ADDENDUM #2

TITLE: Design Build Services for East Bay Bike Path Bridge Replacement

RFP #7670815 – DESIGN BUILD SERVICES FOR EAST BAY BIKE PATH BRIDGE REPLACEMENT
(REQUEST FOR PROPOSALS)
ADDENDUM #2
SUBMISSION DUE DATE: April 1, 2022 at 11:00 am

1. RFP Part 1 Revised Section 6.7, 8.6 and 8.7.1
2. BTC Plans Revisions to General Bridge Notes Sheet 1 of 4
3. BTC Plans Revision to survey location and callout of aerial utility pole on sheet 19.
4. Mandatory Specs Revision to estimated dollar figure noted for “Management & Disposal of Regulated Soils”.
5. RFP Appendix B.08 Additional of NGRID proposed utility relocation plan.

Proposed MH&D System for East Bay Bridges – Sheet 2 of 2

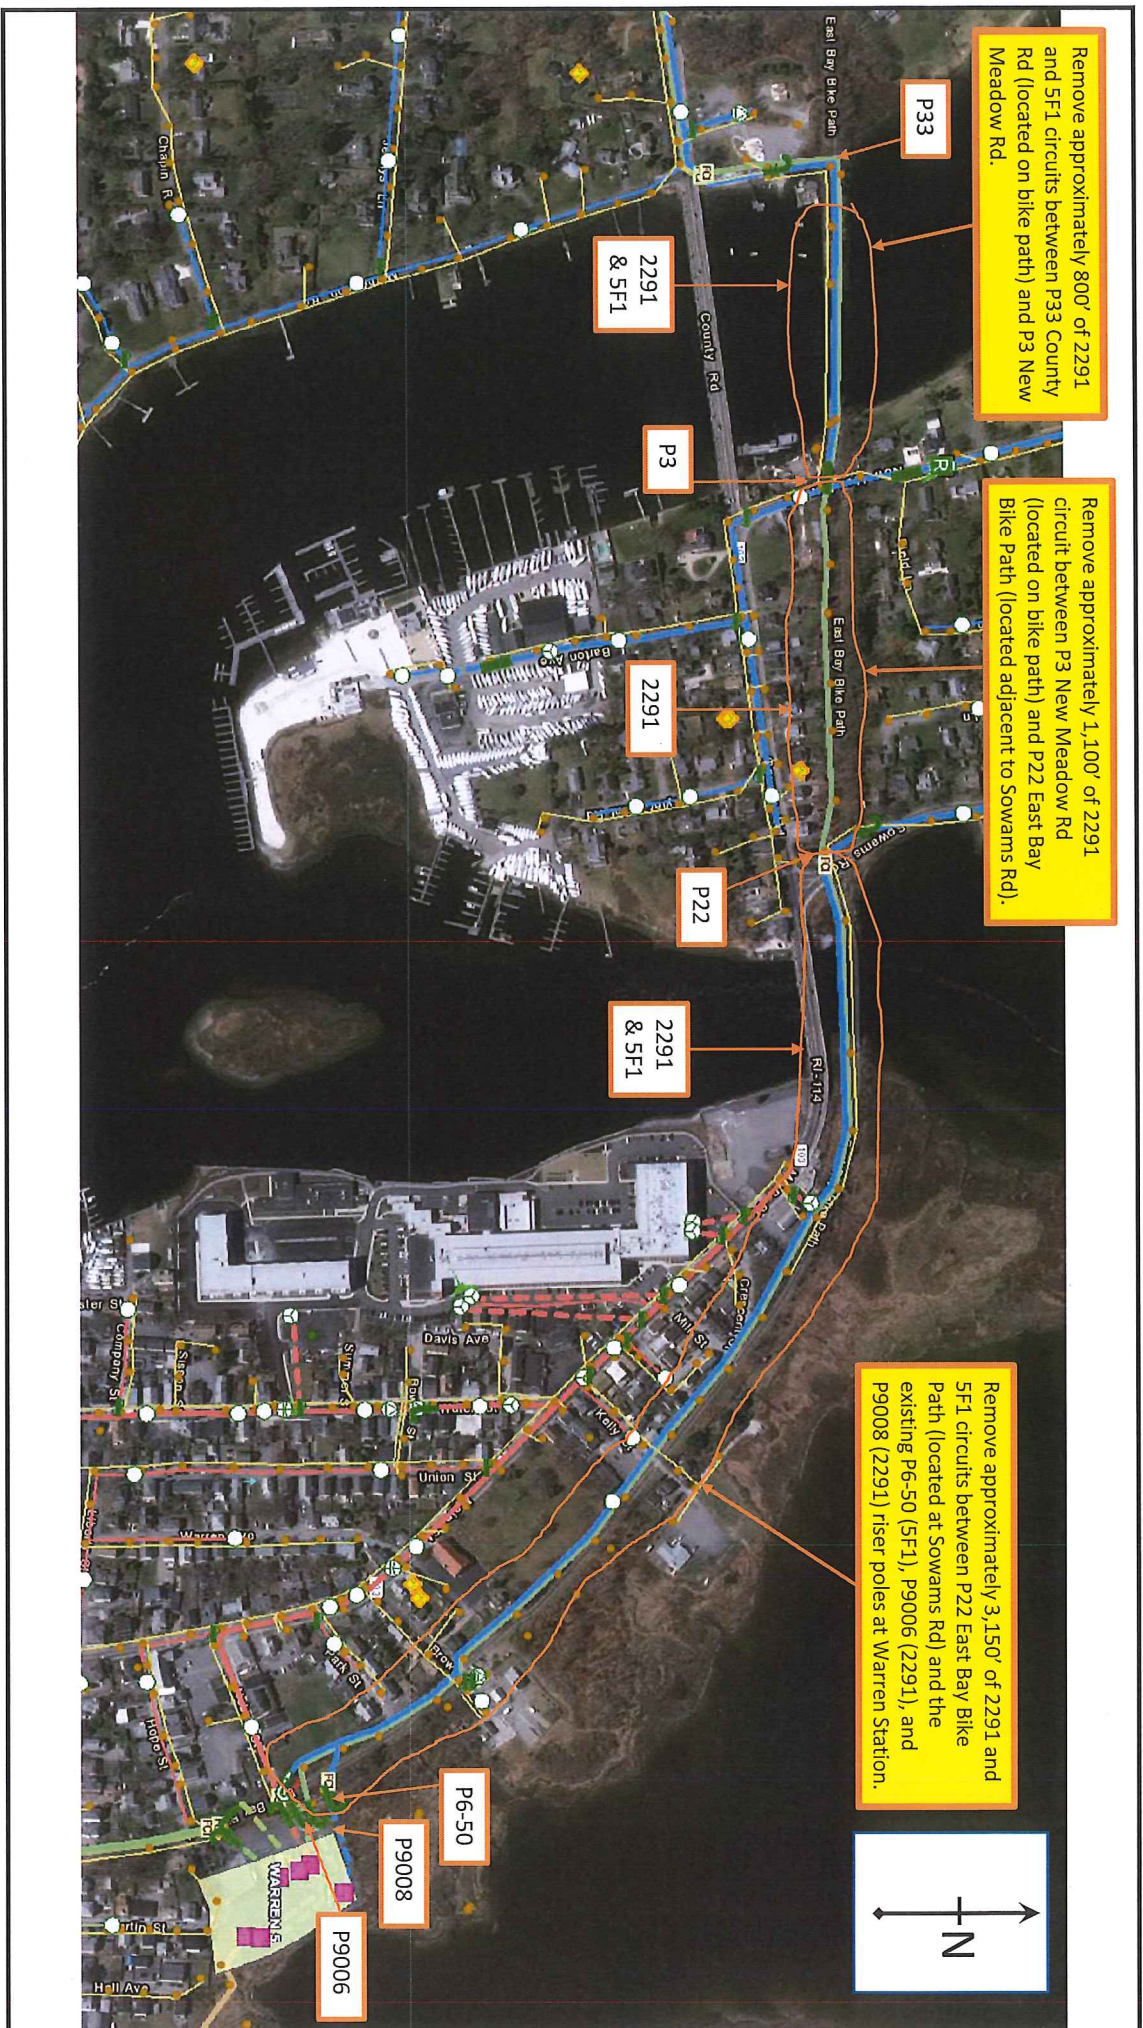
Remove approximately 800' of 2291 and 5F1 circuits between P33 County Rd (located on bike path) and P3 New Meadow Rd.

Remove approximately 1,100' of 2291 circuit between P3 New Meadow Rd (located on bike path) and P22 East Bay Bike Path (located adjacent to Sowams Rd).

Remove approximately 3,150' of 2291 and 5F1 circuits between P22 East Bay Bike Path (located at Sowams Rd) and the existing P6-50 (5F1), P9006 (2291), and P9008 (2291) riser poles at Warren Station.
